# Newcastle Inner City Bypass - Rankin Park Jesmond Stage 2 IEA

Prepared for Transport for NSW  
May 2020

## Independent Audit Declaration Form

Figure 2.3 - RMS land parcels highlighted

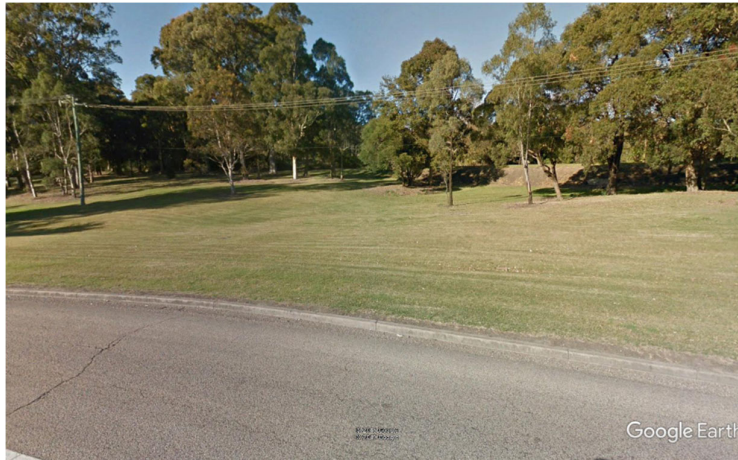
CN suggests Daracon investigate alternative sites for construction parking – see figure 2.3 and 2.4 subject to relevant approvals and traffic control plans being acquired.

Figure 2.5 – existing road shoulder and footway- west of Robinson Avenue.

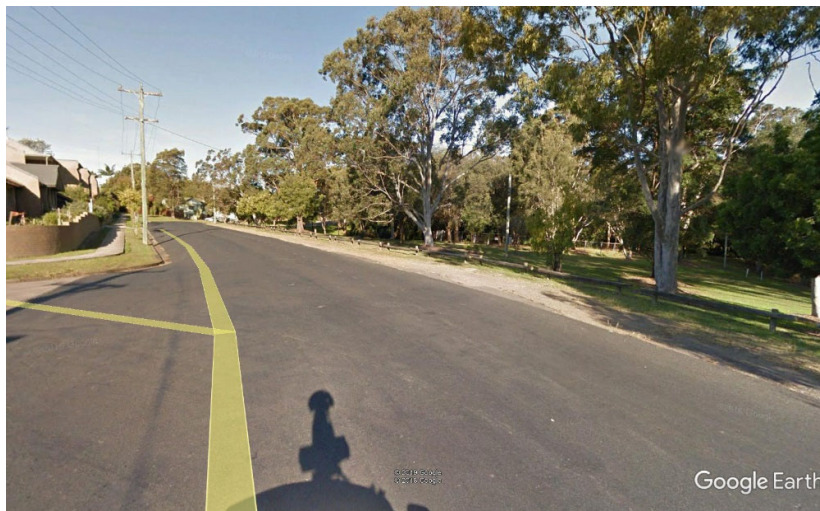
Given the likely conflicts at the three sites in Figures 1.1-1.3 inclusive; Daracon is advised to investigate the feasibility of using the road shoulder and footway on the western side of Robinson Avenue for parking, shed storage and materials stockpiling. An indicative location is shown in Figure 2.5.

This alternative option will still require preparation and implementation of a CN approved Tree Protection Plan; Tree protections; dilapidation testing; Traffic Controls and Approvals and resident notification as per 2.0.
